Your Ref
M/48/15/HH
Our Ref
PLAN-009763
Date
15/05/2015

Proposal: Single storey rear extension & loft conversion.
Site: 17 Ancton Drive, Middleton on Sea, PO22 6NB.
M/48/15/HH

Southern Water has no objection to the above proposal.

Southern Water MapGuide Browser

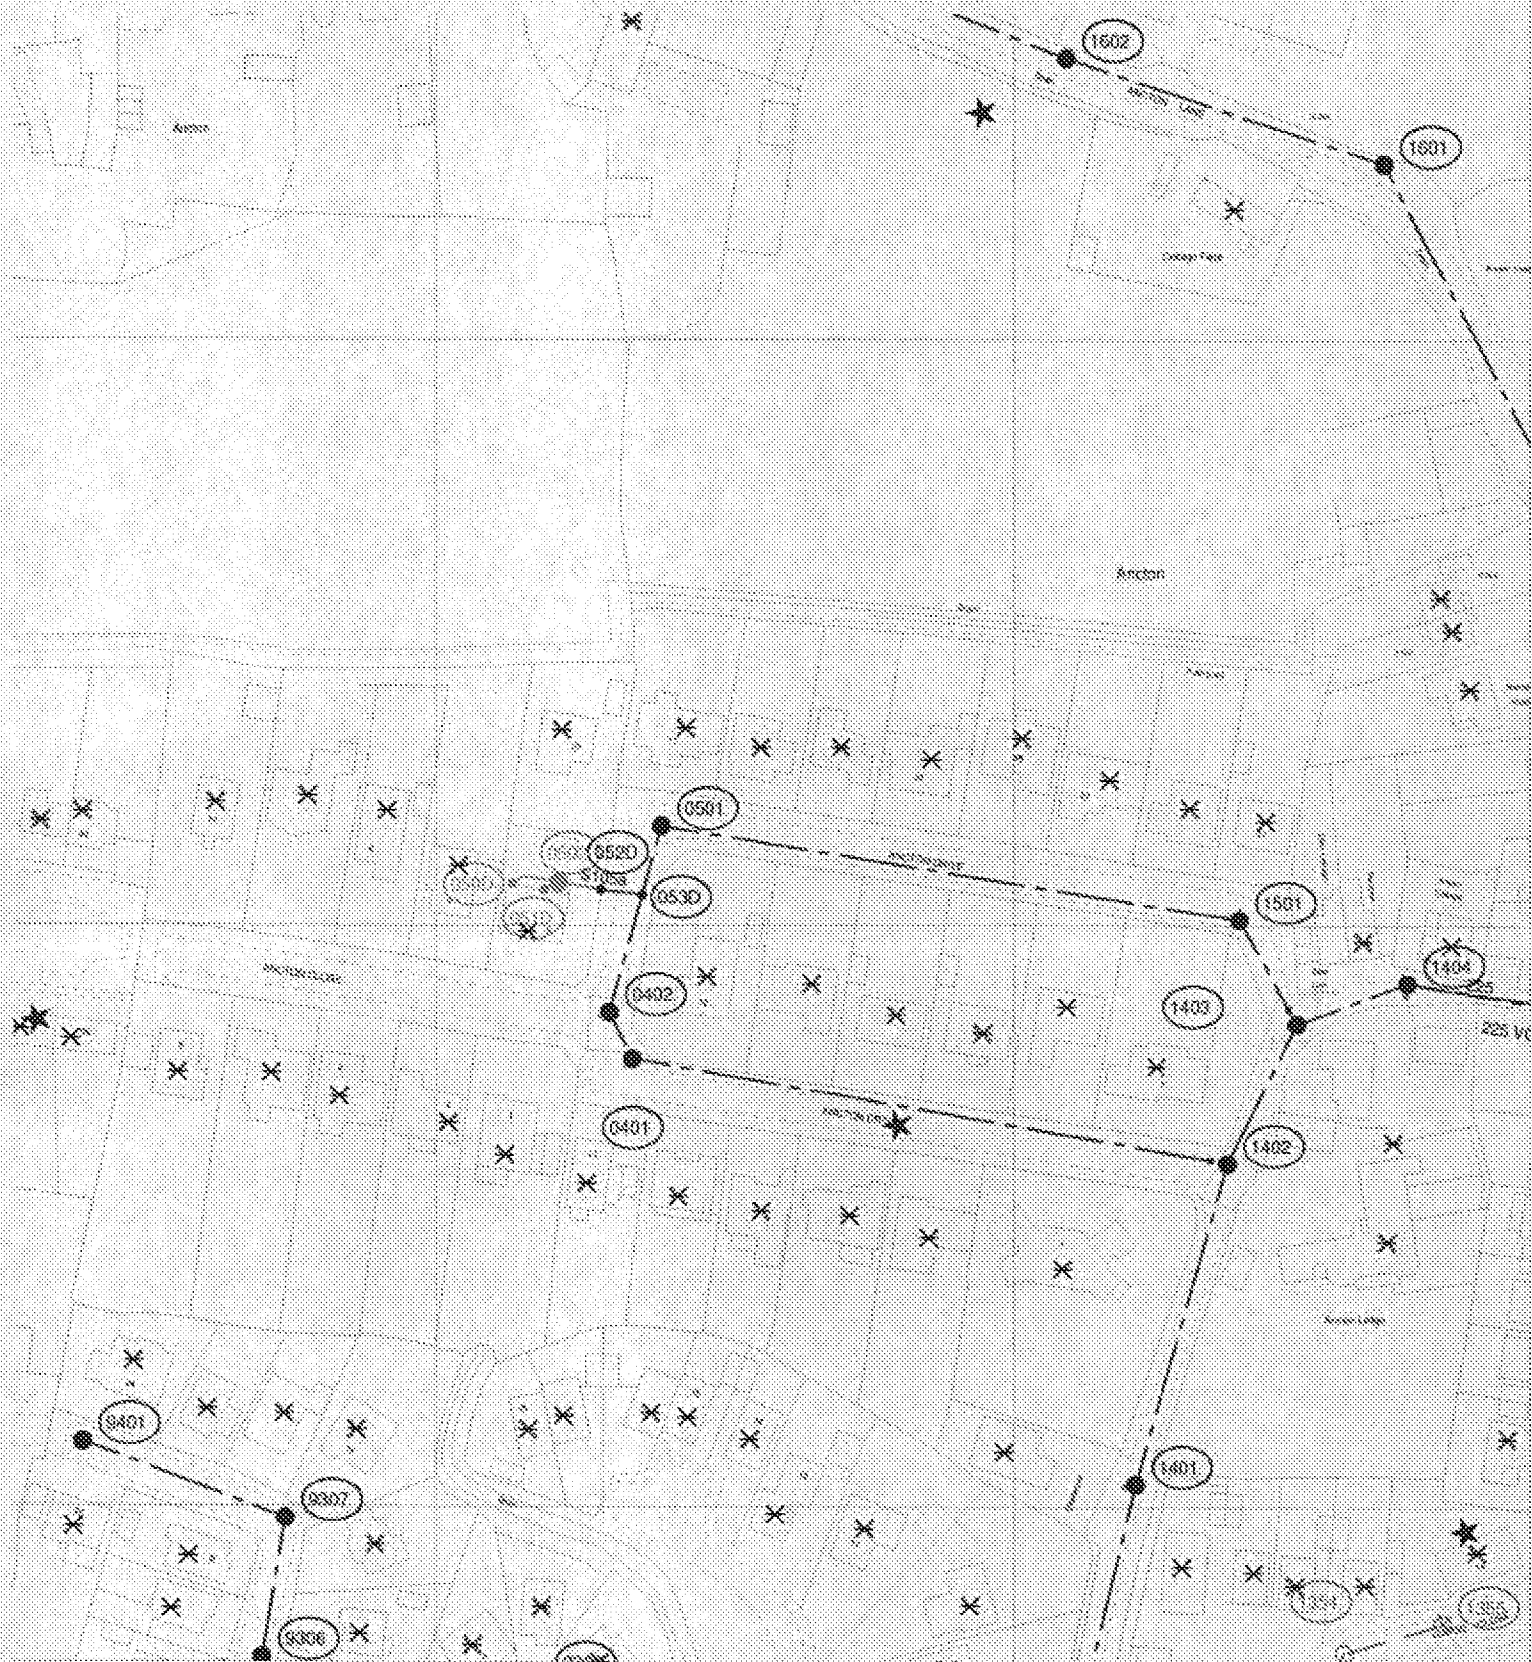
Due to surface water inundation issues in the Lidsey Catchment "The applicant is advised to adopt, where appropriate, the measures in the table "Practical measures to reduce the potential impacts of development".

Developer should look to protect the public sewerage system from inundation and infiltration, which contribute to flooding in unfavourable conditions.
